CASE OFFICER'S REPORT

Application Reference:	PL/2023/06872
Date of Inspection:	
Date site notice posted:	Sent to site owner
Date of press notice:	
SITE ADDRESS:	60 St Ann's Street, Salisbury
PROPOSAL:	Internal works including works to two windows

Ground floor

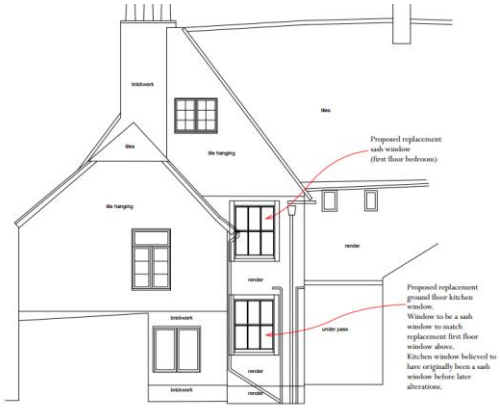
The proposal is to move the existing internal door to the kitchen over towards the chimney breast and construct a nib wall abutting the outside wall.

The proposal to move the door would cause some minor harm ie possible disturbance of historic fabric (date unknown but not medieval). In the context of the whole, this harm would be negligible.
